1 VAUGHAN HEALTHCARE CENTRE PRECINCT PLAN (THE "VHCP" PLAN)
NORTHWEST QUADRANT OF JANE STREET AND MAJOR MACKENZIE DRIVE
CITY OF VAUGHAN RESPONSE TO PUBLIC, GOVERNMENT AND
AGENCY SUBMISSIONS
FILE 15.107.3
WARD 1

#### **EXTRACT FROM COUNCIL MEETING MINUTES OF NOVEMBER 19. 2013**

# Vaughan Healthcare Centre Precinct Plan

Figure 7: Pedestrian & Bicycle Circulation and

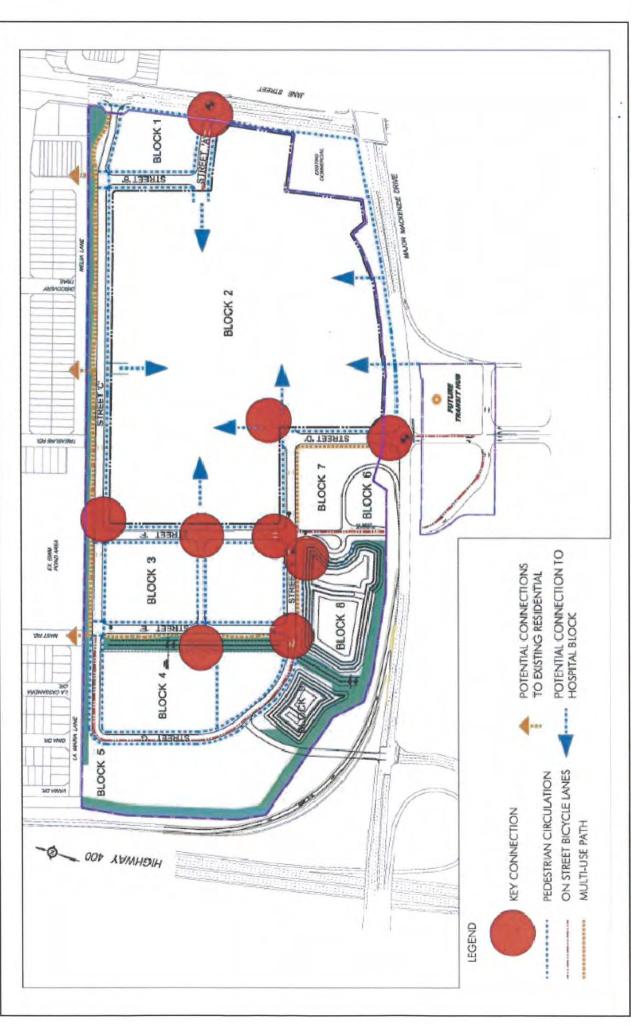
The Region of York has asked the City to consider the potential to use the existing easterly Major Mackenzie Drive underpass as a future pedestrian/bicycle link between the future Transit Hub on the south side of Major Mackenzie Drive and the new hospital site to the north. Figure 7 (Attachment 7), as shown in the November 5, 2013 Committee of the Whole staff report, shows the crossing farther to the east of its actual location. The replacement Figure 7 shows the actual location of this link, further to the west - adjacent to the Future Transit Hub.

It is appropriate to consider the existing Major Mackenzie Drive underpass as a future pedestrian/bicycle link between the Transit Hub and the hospital site. The revised Figure 7 more accurately depicts its location. Therefore it is recommended that the revised Figure 7 attached hereto replace the Figure 7 which forms Attachment 7 to Item 1 of the Special Committee of the Whole meeting of November 5, 2013.

THAT Attachment 7 of the Report of the Commissioner of Planning, dated November 5, 2013, with respect to Vaughan Healthcare Centre Precinct Plan (The "VHCP" Plan) be deleted, and replaced with the revised Attachment 7 - Figure 7: Pedestrian & Bicycle Circulation and Connections Plan (Modified Nov. 5, 2013), attached hereto.

Figure 9: Angular Plane

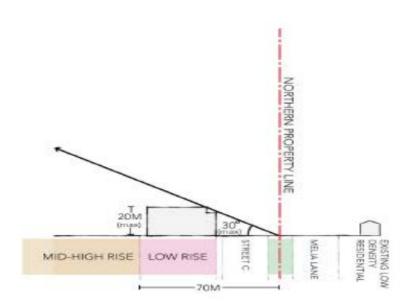
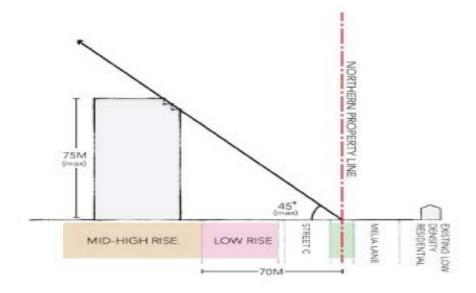
- "Transitional Area" lands extending south to the point where the rising 30° angular plane intersects with max height permitted by 'High-Rise" designation (75 m), approx. 130 m from the north property line.
- Amendment to Figure 8 "Height" and Figure 9 "Angular Plane" to increase distance of "High-Rise" development away from community to north.
- Requirement for 3D Visual Impact Assessment to residential community to the north for lands within "Transitional Area".

That Figure 8 "Heights" (Attachment 3), Figure 9 "Angular Plane" (Attachment 4) be replaced by Figures 8 and 9 as shown in Attachment 3 and Attachment 4; and that the policies of Sections 1.2.1.(4), 4.3 and elsewhere in the Plan, be modified to reflect the amended Figures.

# Figure 14: Option 2 – Sanitary Sewer System *(modified)*

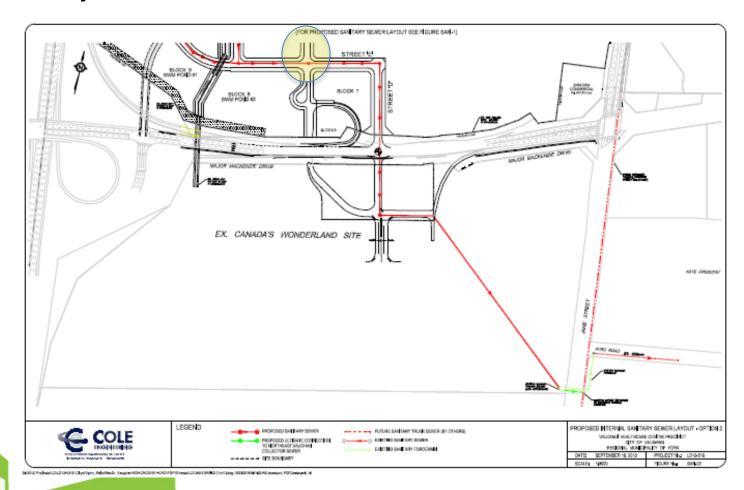
Location of public infrastructure under Street "F" will encumber lands required for expansion and regeneration for hospital uses.

- Modify Figures 13 (Option 1 Sanitary Sewer), 14 (Option 2 Sanitary Sewer) and 16 (Water Supply System) to remove proposed infrastructure within the Street "F" right-of-way;
- Revise Sections 7.1 "Sanitary Sewers" and 8.4 "Infrastructure" to restrict placement of permanent municipal infrastructure such as major sanitary and water lines under the proposed Street "F".

Figure 8: Heights (Modified Nov. 5, 2013)

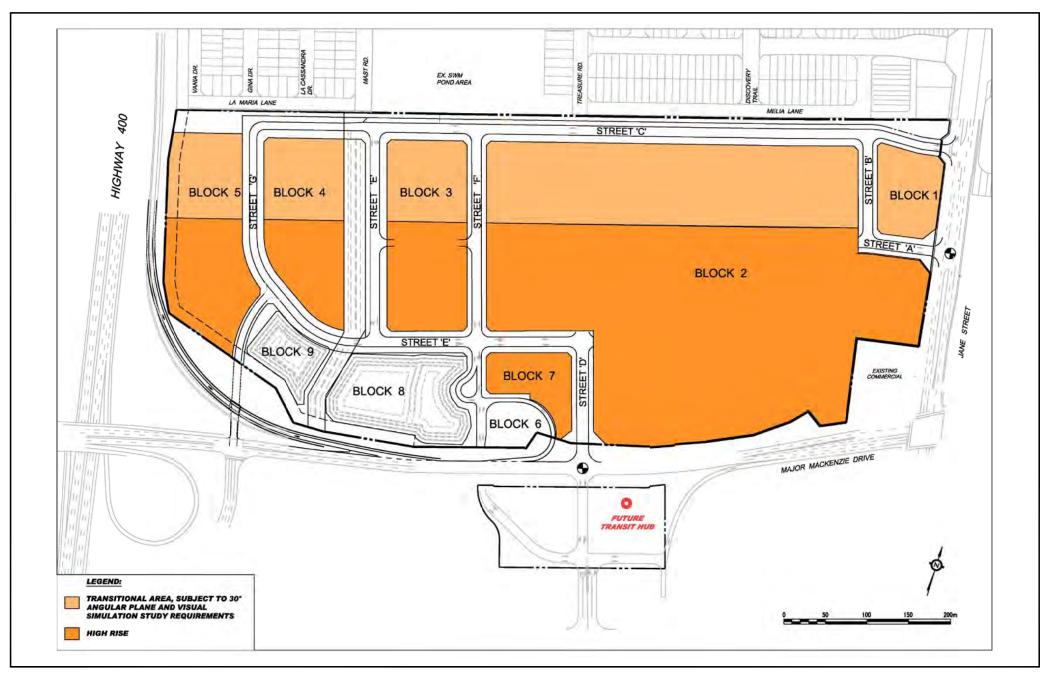
City staff and consultants have met with the Ward Councillor and Mackenzie Health to discuss this issue. As a result, the following measures are recommended to address the concerns, which will be reflected in Figure 8 "Heights" and Figure 9 "Angular Plane":

- Maintain the High Rise designation (maximum height 75 m) across the southerly portion of the site;
- Eliminate the Mid Rise and Low Rise designations in the northerly portion of the site:
- Replace the Mid Rise and Low Rise designations with a new Transitional Area designation, which is based on a 30 degree angular plane extending south from the northern border of the VHCP line which will define the maximum building heights within that zone;
- The Transitional Area will extend south to the point where the rising 30 degree angular plane intersects with the maximum height permitted by the High Rise designation (75 m), approximately 130 m from the north property line or boundary of the VHCP Plan.

This proposed modification will result in a consistent building height transition across the whole northerly portion of the site. By relying solely on the 30 degree angular plane it will allow for a more gradual height transition from the northerly property line to the maximum height permitted in the High Rise area. The designation will provide Mackenzie Health with the flexibility to use adaptive measures, like tiered building forms, to fall within the angular plane.

Figure 13: Option 1 - Sanitary Sewer System (Modified Nov. 5, 2013)

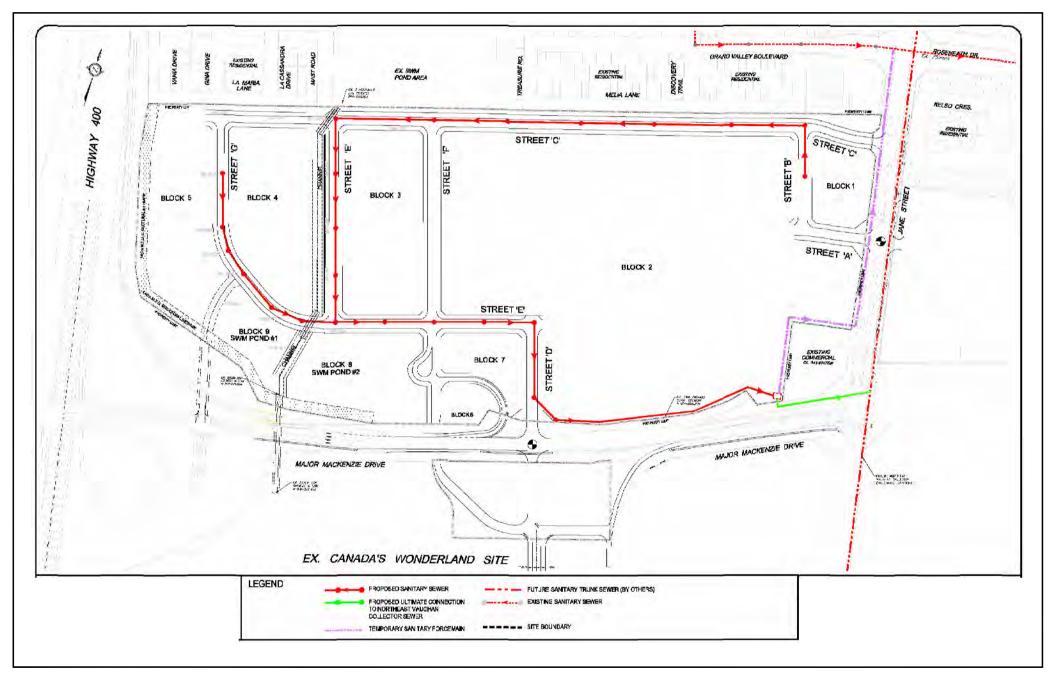
Subsequent to the September 3, 2013 Public Hearing, the City has had ongoing discussions with Mackenzie Health regarding the "permanency" of Street "F". It has been concluded that Street "F" is only required to service the transportation component of the site for the purposes of managing internal traffic capacity. However, the City has agreed to modify the Plan to relocate any subsurface municipal services (water and wastewater) from under Street "F" as shown in Attachments 5 and 6. This will provide more flexibility in the event that it is demonstrated that the lands are required for the use of regeneration and expansion for the hospital use. This will essentially allow for potential road closure and transfer for use of a private entity once required transportation analysis is approved to the satisfaction of the City and other approval authorities demonstrating non-disruptive alternative routes that can maintain the capacity levels.

- That Figures 13 and 16 of the Precinct Plan be modified to reflect the removal of the sanitary sewer and water mains from the Street "F" right-of-way;
- That Sections 7.1.1 "Option 1 Connection to Existing Sanitary Sewer at Jane / Grand Valley" and "Option 2 Section 7.1.2 Connecting to Existing Pumping Station on Canada's Wonderland Property" be modified to include policy to read as "Any subsurface permanent municipal infrastructure such as sewers for water and wastewater, and utilities is not permitted on or under Street 'F";
- That Section 8.4 "Infrastructure" be amended to include the following paragraph:
